HISTORIC AND DESIGN REVIEW COMMISSION

HDRC CASE NO: 2019-632
ADDRESS: 314 LAMAR ST
LEGAL DESCRIPTION: NCB 528 BLK 1 LOT 4
ZONING: R-5, H
CITY COUNCIL DIST.: 2
DISTRICT: Dignowity Hill Historic District
APPLICANT: Timothy Patrick/FDN Home, LLC
OWNER: 10X Properties Investments Series, LLC
TYPE OF WORK: Rehabilitation, construction of a rear addition, and construction of a rear accessory structure
APPLICATION RECEIVED: October 18, 2019
60-DAY REVIEW: December 17, 2019
CASE MANAGER: Edward Hall
REQUEST:

The applicant is requesting a Certificate of Appropriateness for approval to construct a rear, two story addition and enclose an original, covered rear porch.

NEW WORK LEFT SIDE ELEVATION
SCALE: 1/4" = 1'-0"

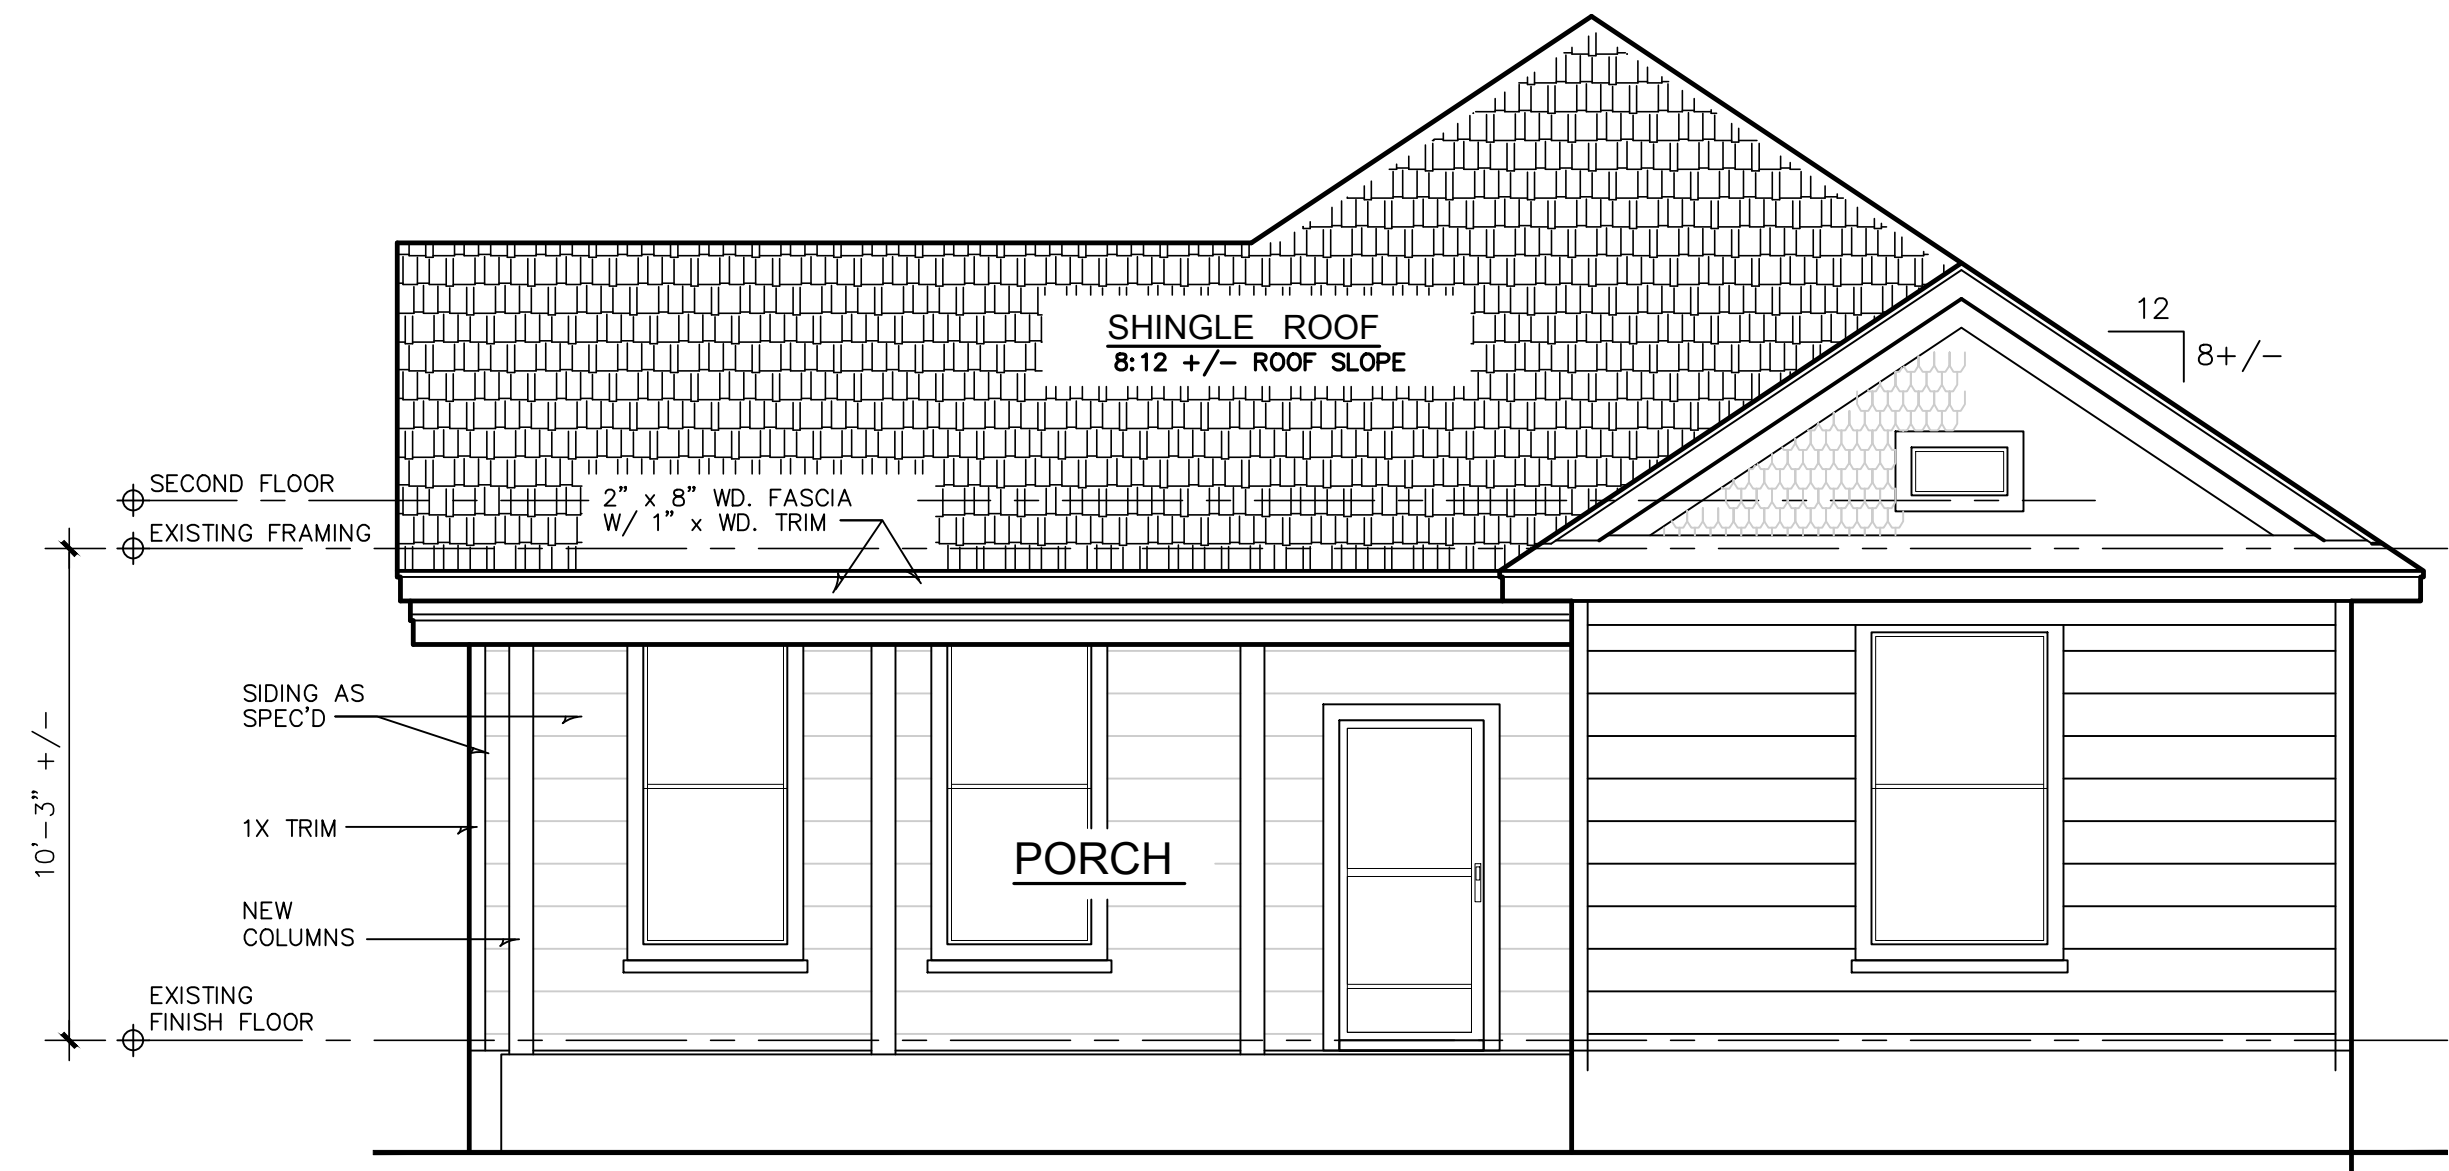
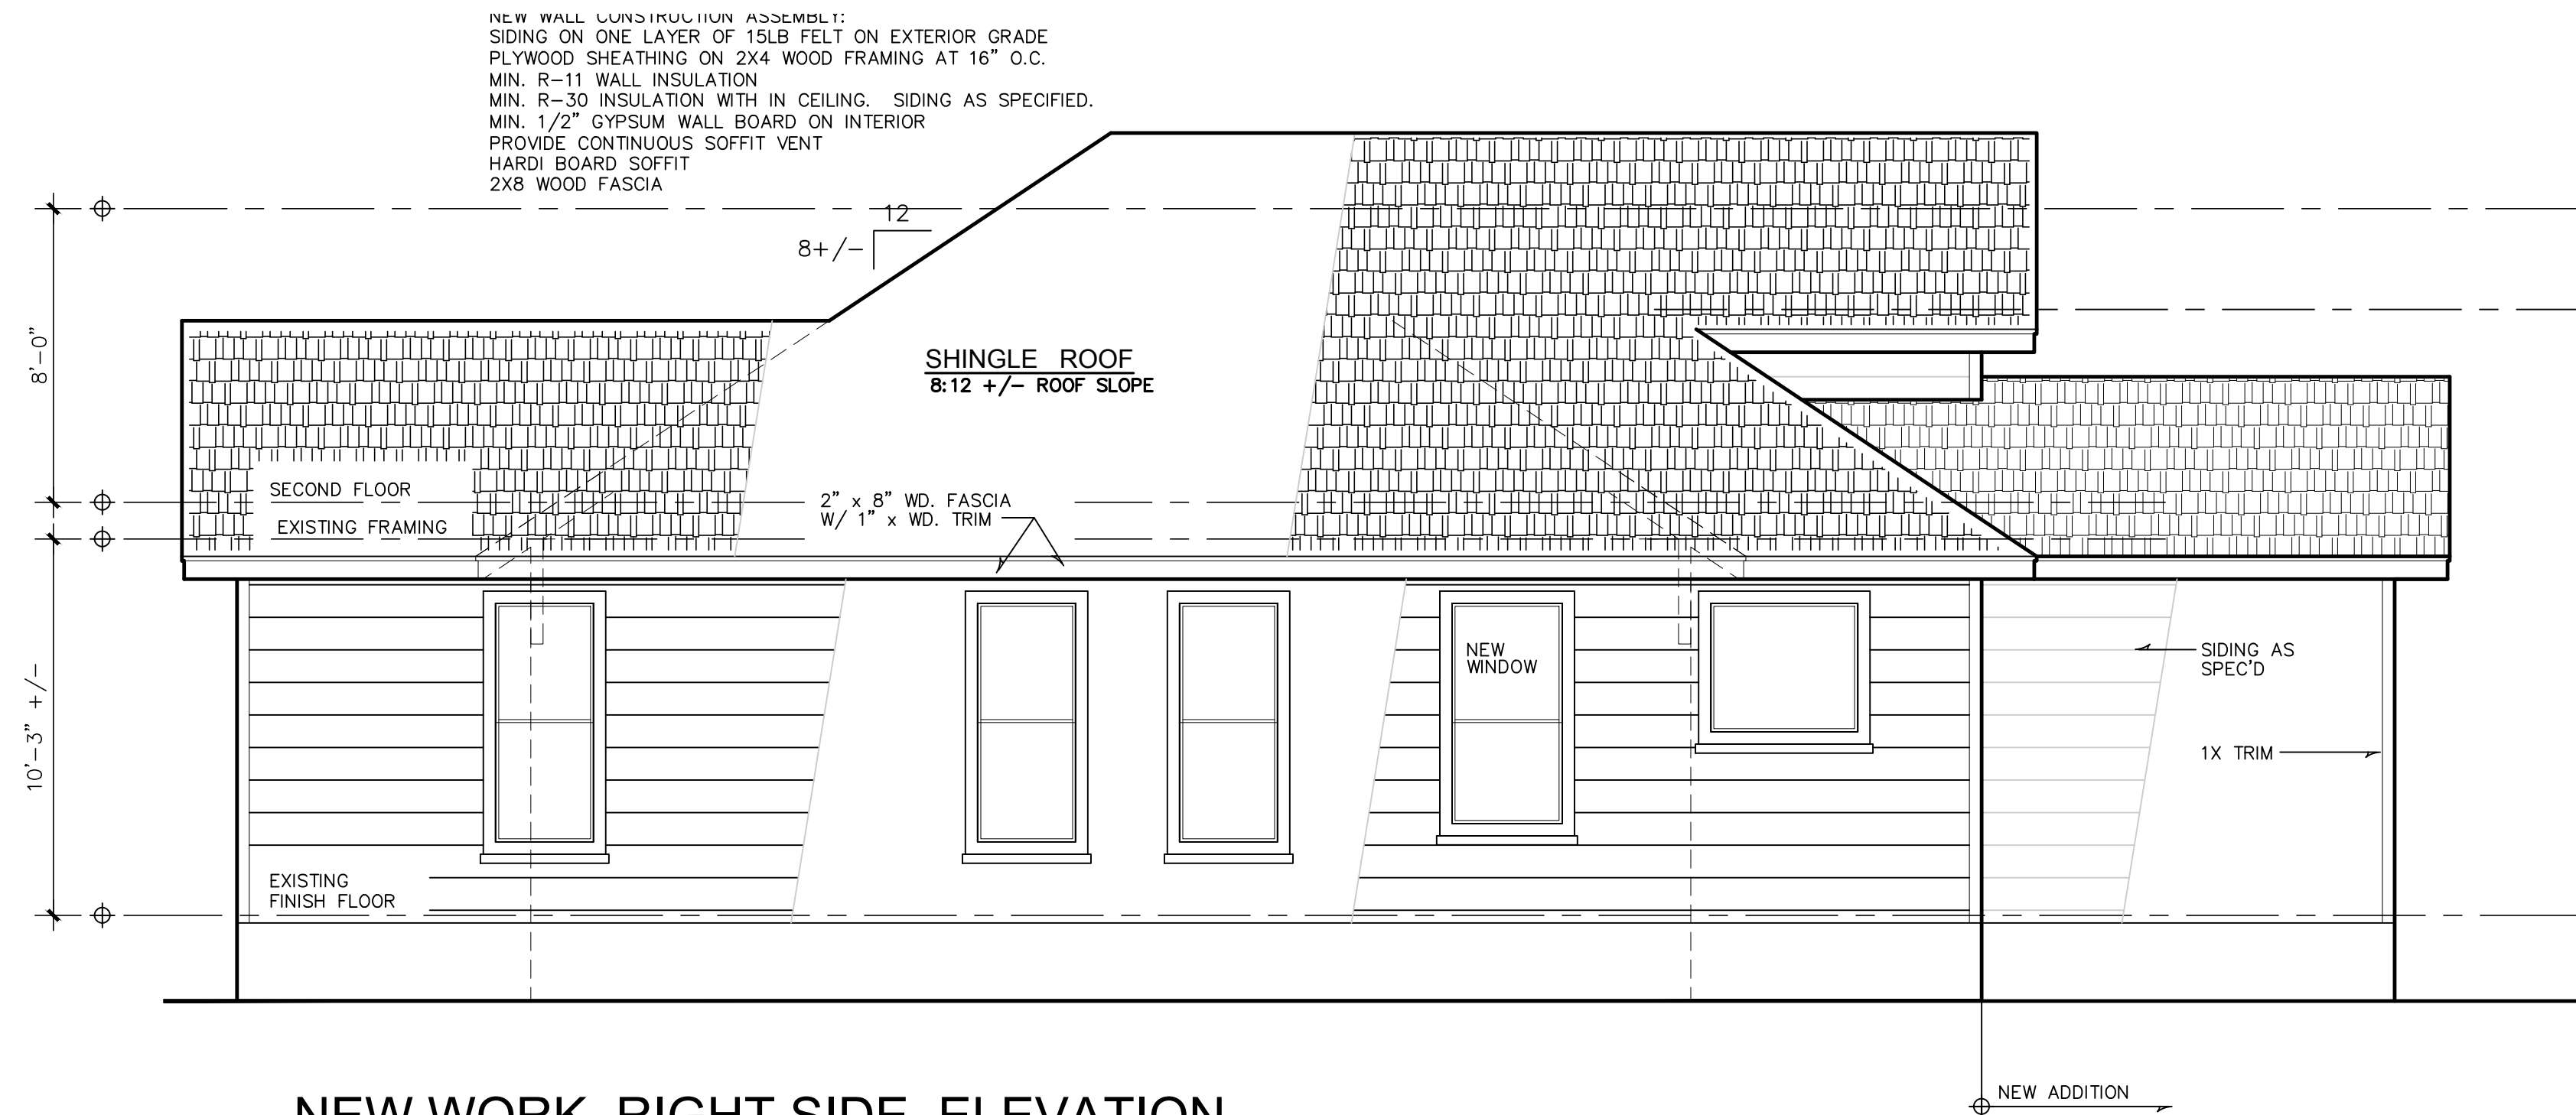
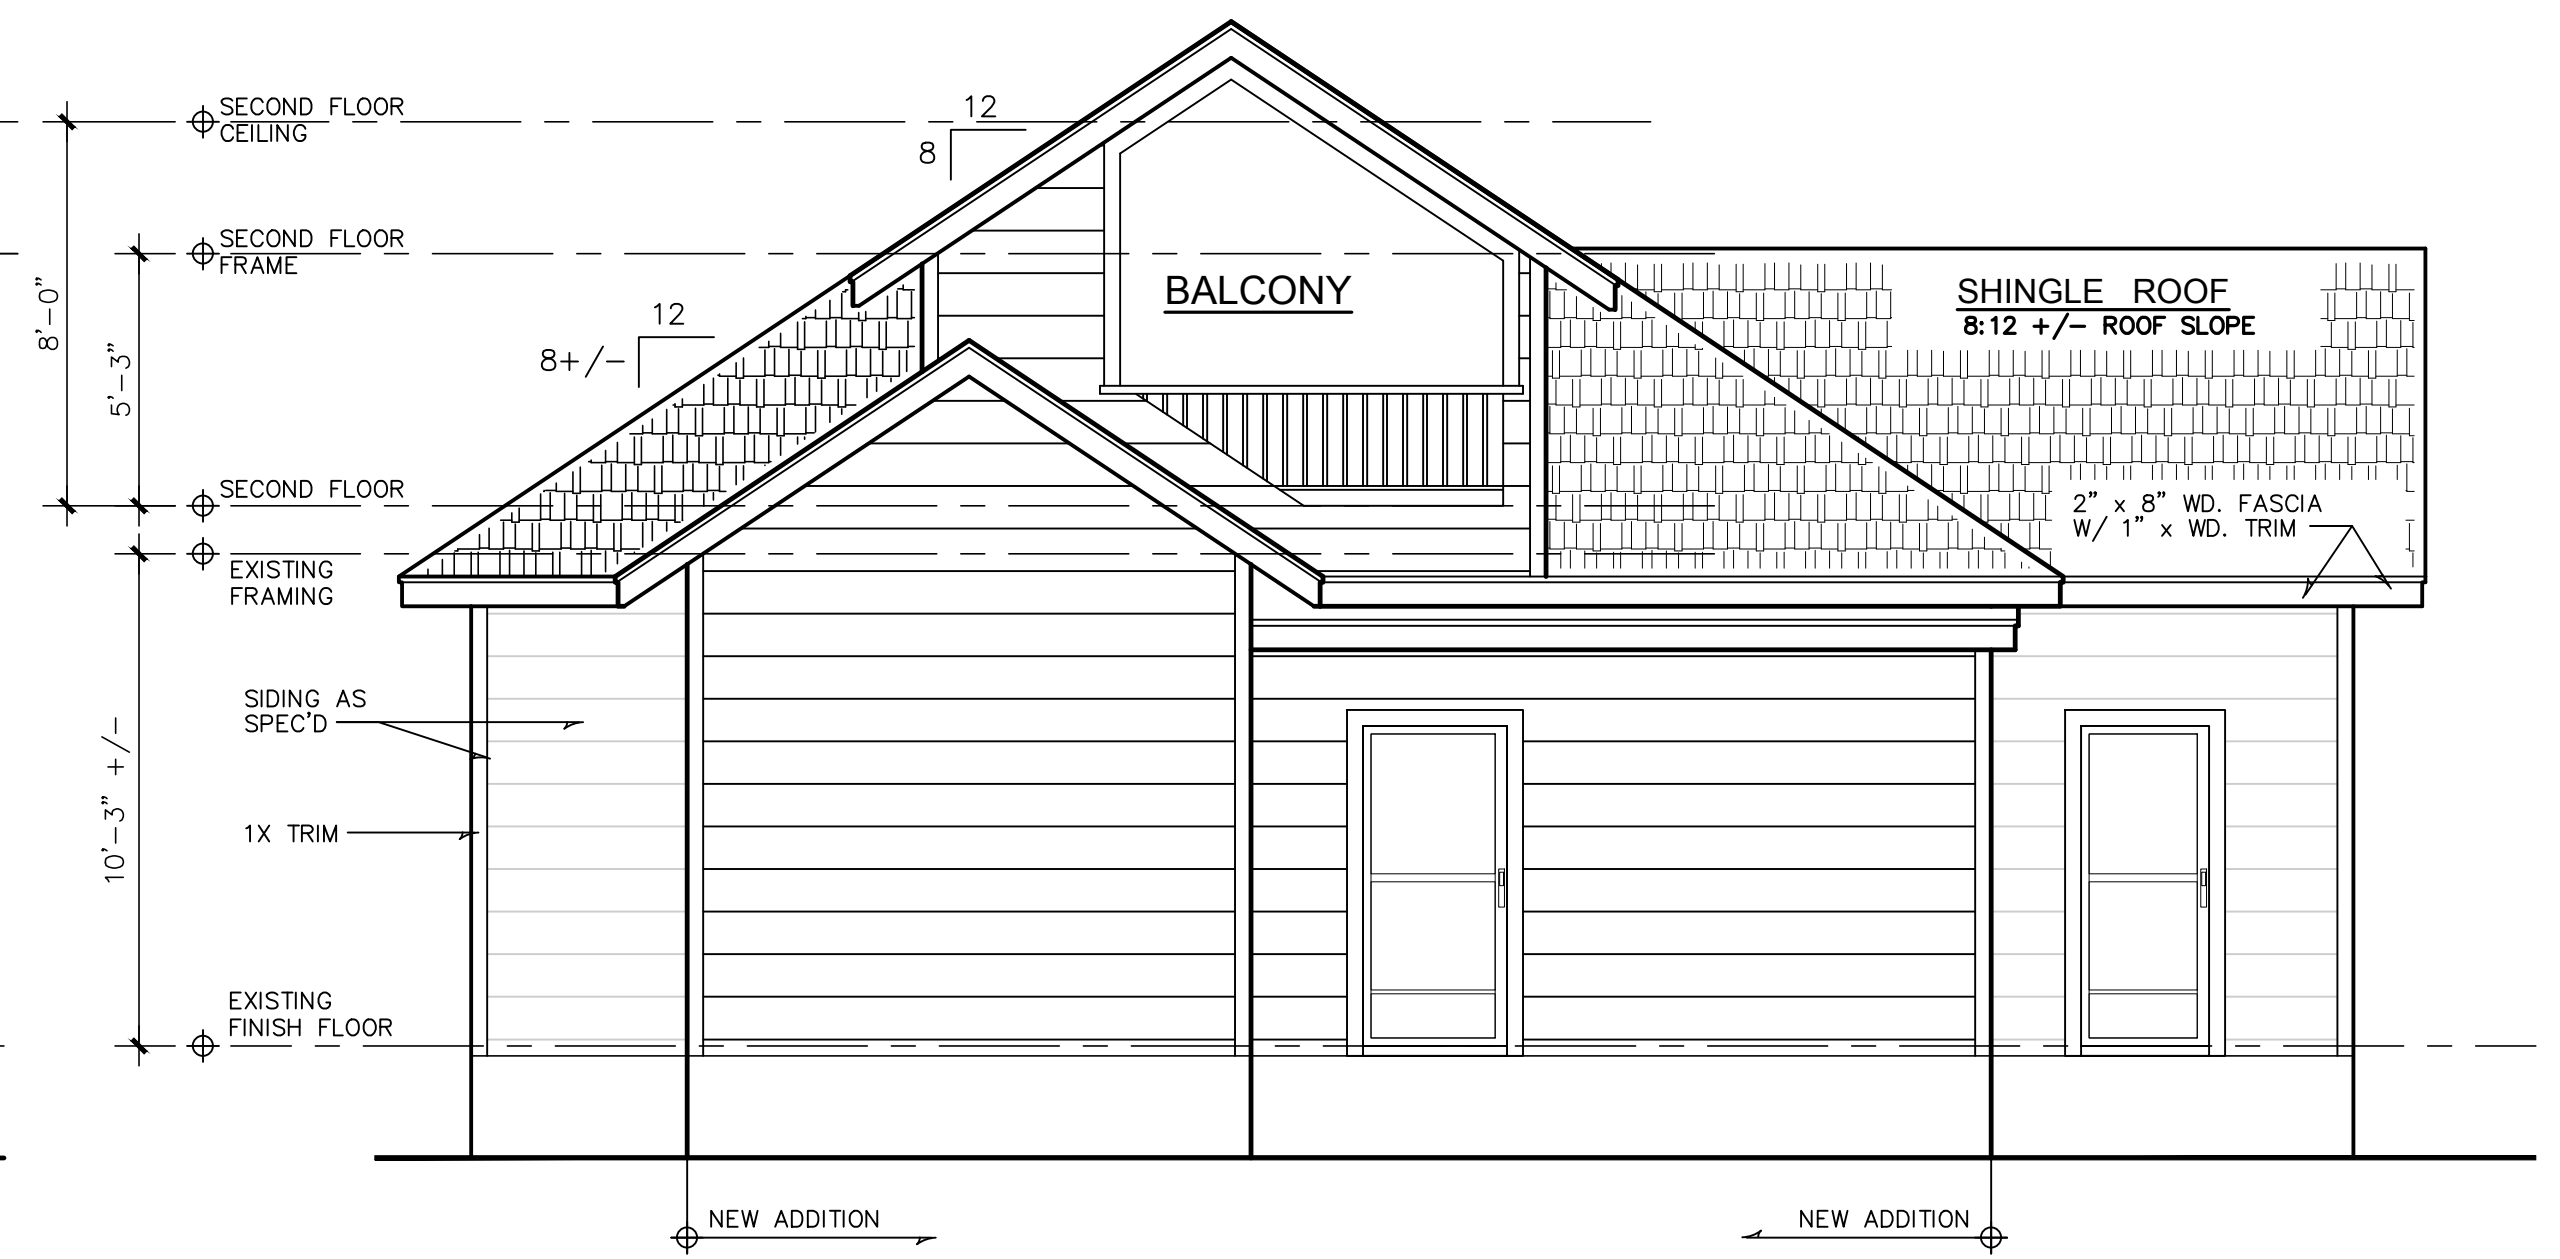
- e. ROOF FORM – The Guidelines note that roof forms should be comparable to those found on the historic house. The applicant has proposed both gabled and hipped roof element. The proposed roof forms are consistent with the Guidelines.

- f. HEIGHT – The applicant has proposed an addition that features a height that is consistent with the historic structure's primary ridge line. Generally, staff finds the proposed height to be appropriate and consistent with the Guidelines.

- i. ARCHITECTURAL DETAILS – Generally, staff finds the architectural details of the proposed addition to be appropriate and consistent with the Guidelines.
